SIB 51 08 22

## WHISTLING NOISE FROM FRONT BUMPER

E-Series	Model Description
G20	(3 Series Sedan)

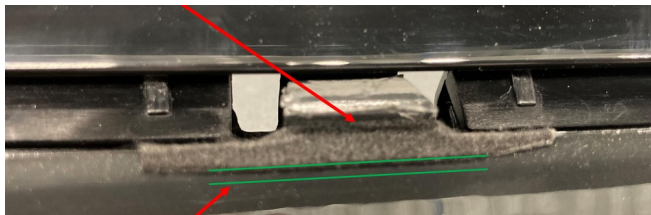
The noise is caused by the bottom clips of the lower grill. (As shown in the photo)

Place felt on the lower clips of the bumper.

3. Attach felt to the lower bumper clips leaving a gap of **1mm** to the front. **Size of felt needed: Length: 40mm, Width: 4mm.** (As shown in the photo).
